Re: Amendment to Cobble Hill Landfill Updated Final Closure Plan 2019

PROJECT:
**COBBLE HILL LANDFILL
 UPDATED FINAL CLOSURE PLAN
 2019**

SCALE: 1:2,000	DATE: 2019/04/18 yyyy/mm/dd	PROJECT NO: PRJ 18074
DESIGNED SG	DRAWING NO: FIGURE 10-1	
DRAWN MG		
CHECKED TS

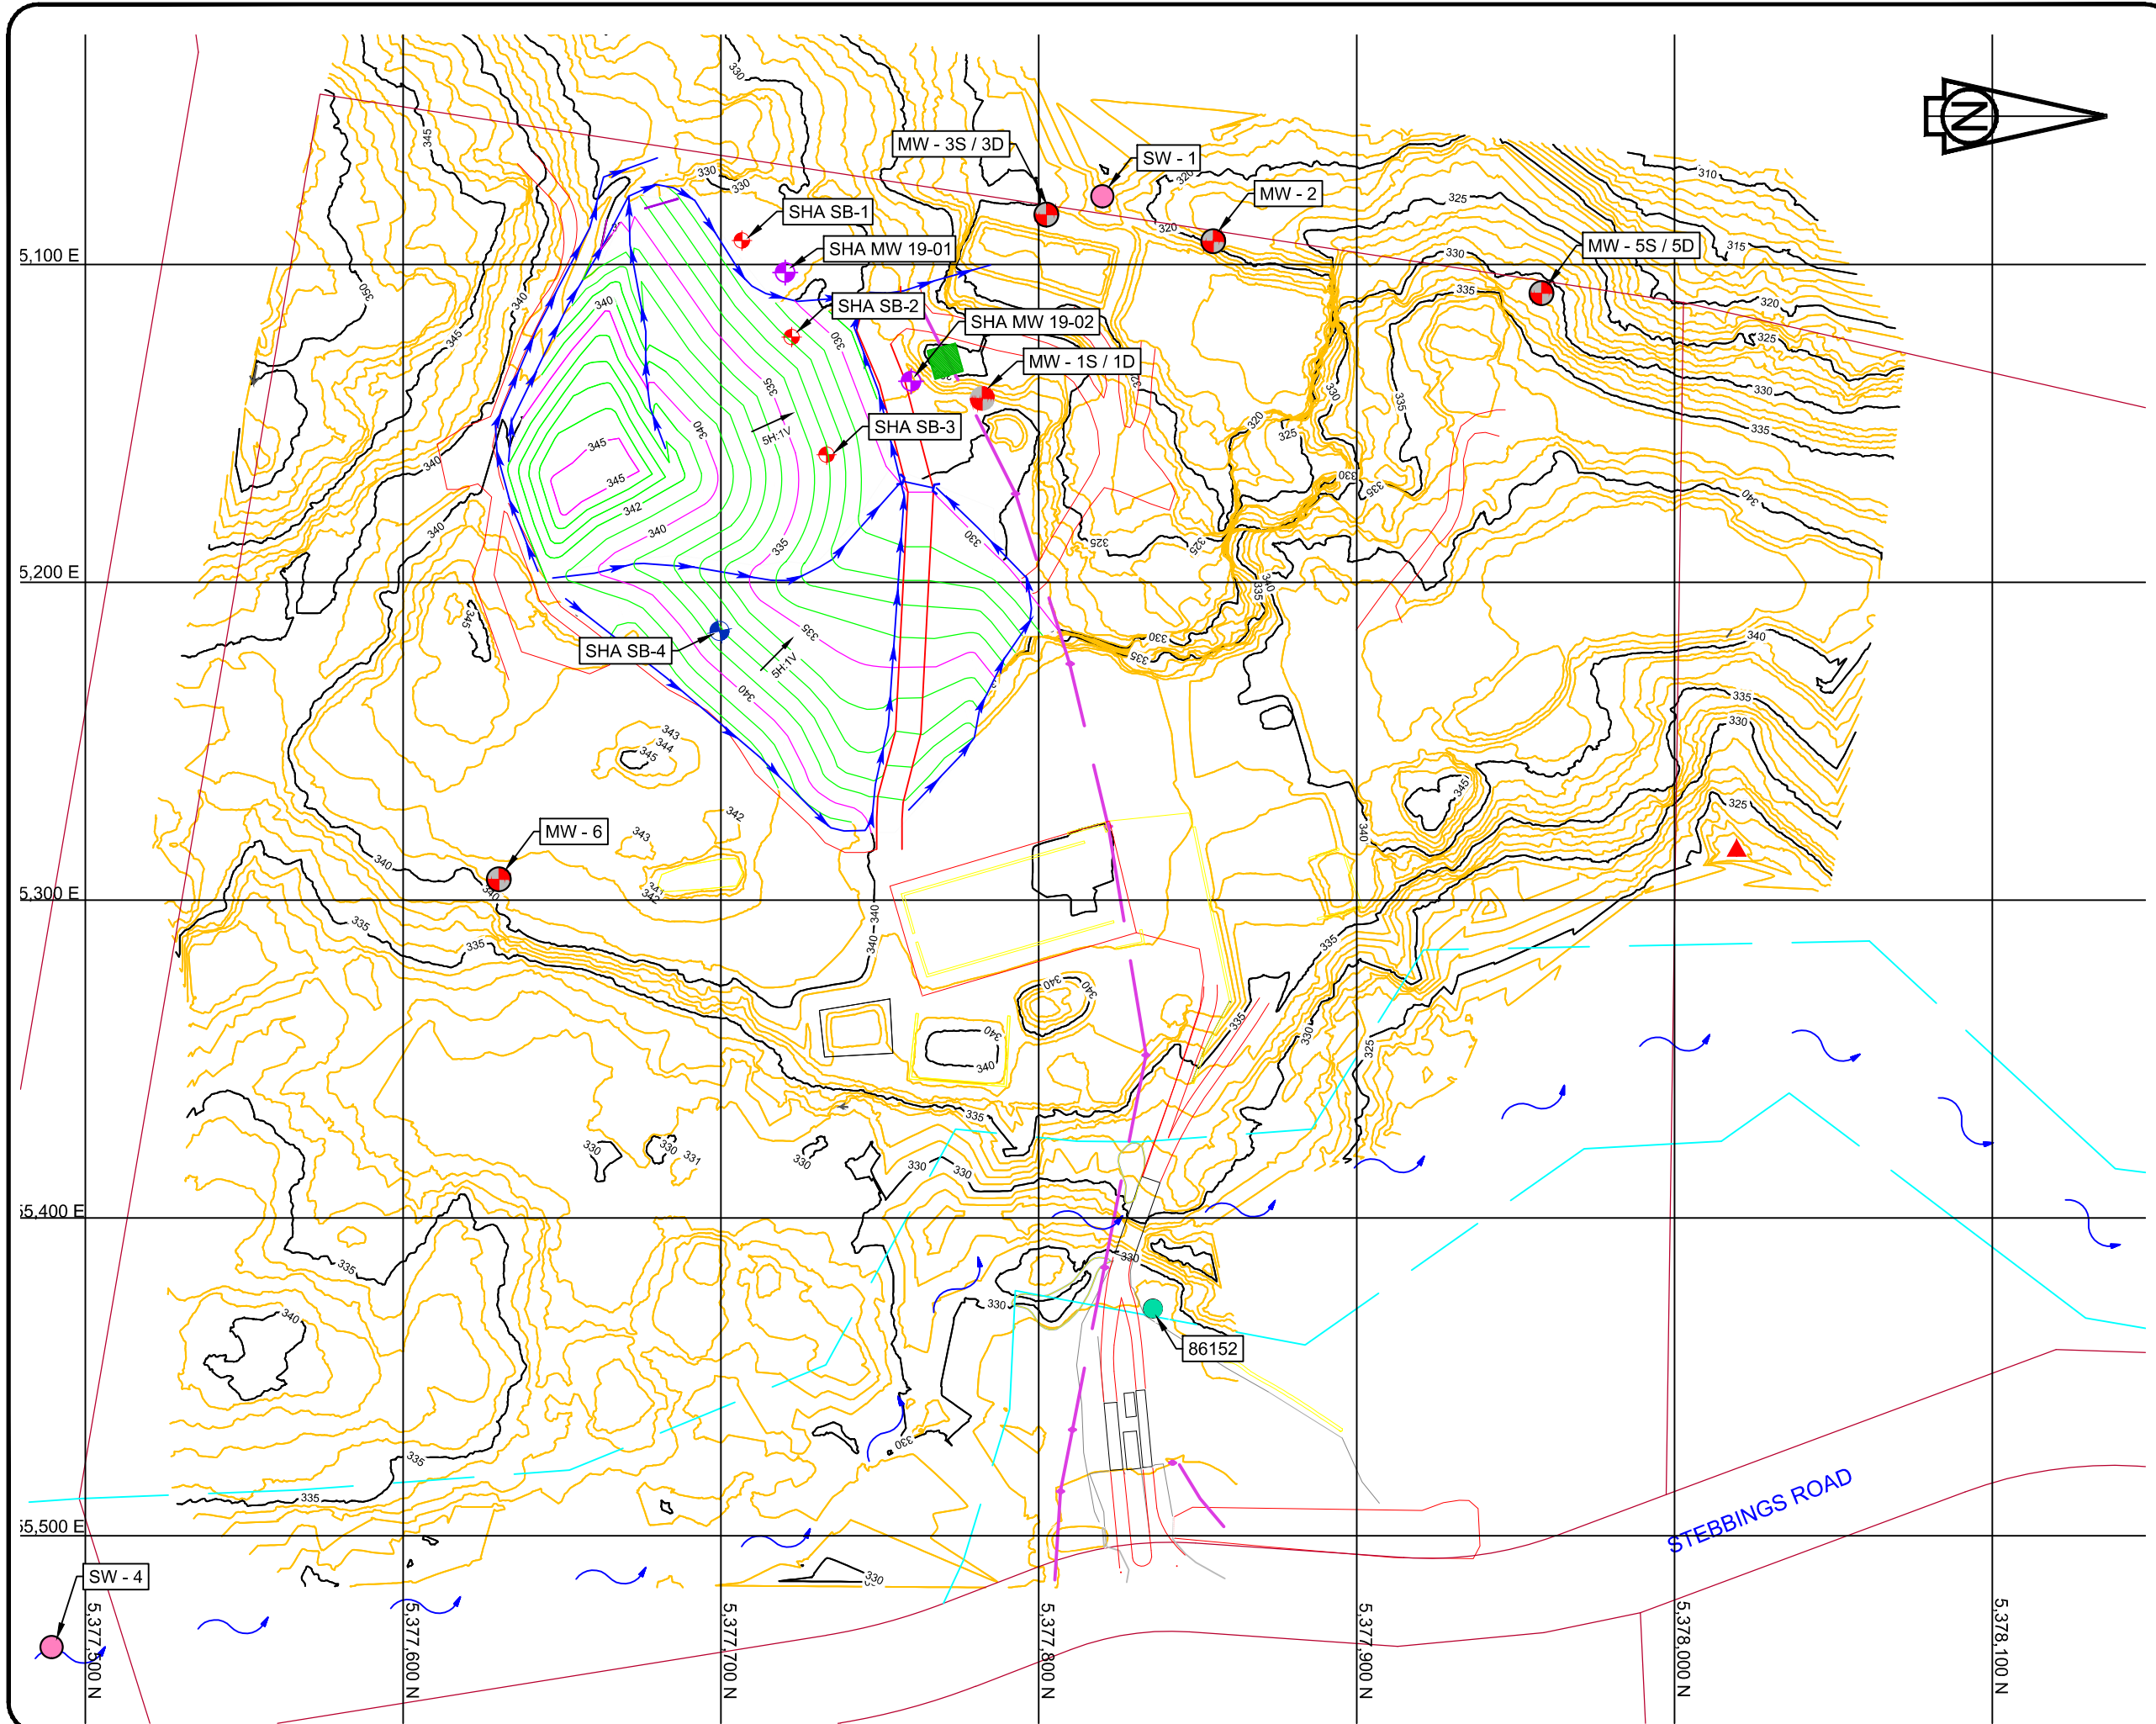
To provide a more stable data set where any increase in concentration in leachate indicator parameters can be more easily noticed, it is proposed that two new shallow groundwater wells be drilled at downgradient locations SHA MW 19-01 and SHA MW 19-02, at the landfill toe, centrally located between seepage blanket wells SB-1, SB-2 and SB-3. The locations of the proposed monitoring wells are shown on Figure 10-1, attached. It is proposed that the wells be drilled to a depth of 10.0 m, below the expected depth of blast induced fractures. The wells are to be screened between 5 and 10 m to

In response to concerns raised by members of the Shawnigan Lake Research Group that groundwater in the seepage blanket may be flowing to the east rather than to the north, as a further protective measure, SHA recommends installing a fourth shallow seepage well SB-4 on the east side of the Permanent Encapsulation Area. Because SB-4 will be in an area that will be receiving additional stabilizing fill, we propose that the well be established prior to fill placement, and the pipe be extended to surface as the fill material is placed at a 5H:1V slope. Again, the location of the well is shown on Figure 10-1.

Figure 2. Cobble Hill Permanent Encapsulation Area – Static Stability Analysis

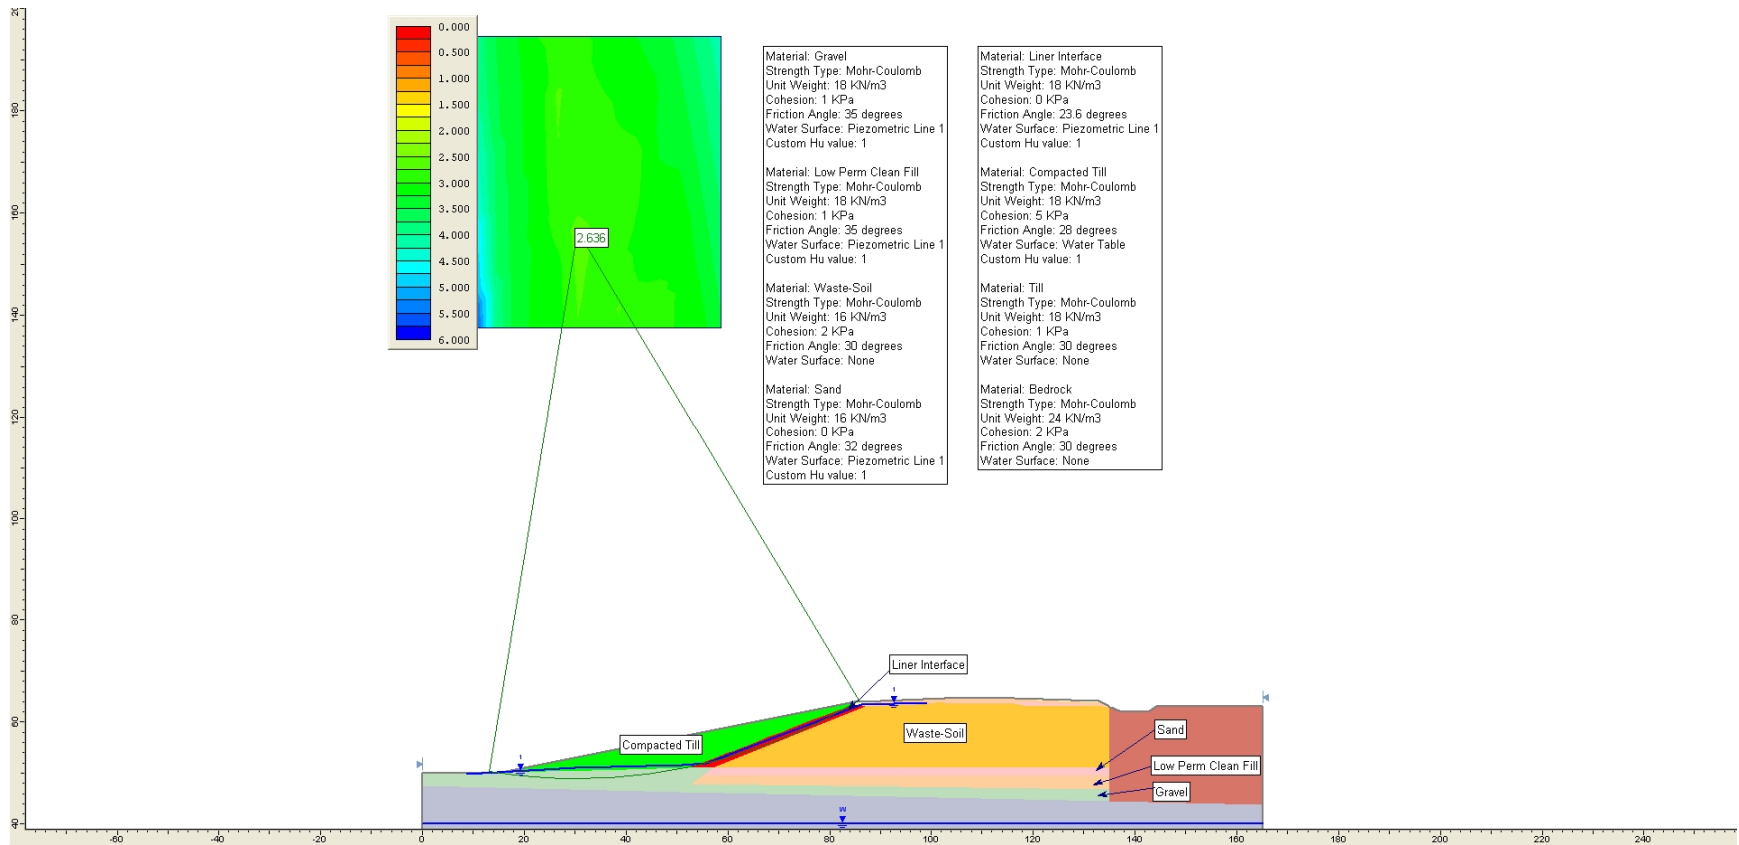
In the same letter, GHD also commented *“SHA has carried out stability analyses utilizing Rocscience’s SLIDE 4.0© using the Bishop Simplified method, a limit equilibrium analysis method. The Bishop’s Simplified method is an established method of stability analysis, however, it does not satisfy all equilibrium conditions, e.g., it does not satisfy horizontal force equilibrium and does not take into account interslice shear. These factors typically effect the computed factors of safety values to some degree, with Bishop’s Simplified method sometimes providing slightly higher factors of safety compared to methods that satisfy all conditions of equilibrium such as Spencer and Morgenstern-Price. It is, therefore, recommended that the analyses should be verified by using either Spencer or Morgenstern-Price methods of limit equilibrium.”*

In response to the concerns raised by GHD, SHA reanalyzed the subject slope with the Spencer method. The results for both static and seismic are attached in Figures 2 and 3 respectively. Of interest, the Spencer analysis (results attached) yielded very similar but slightly higher factors of safety for both static (2.636) and seismic (1.153) conditions than the FOS generated by the Bishop method presented in the Updated Closure Plan (2.615 for static and 1.119 for seismic).
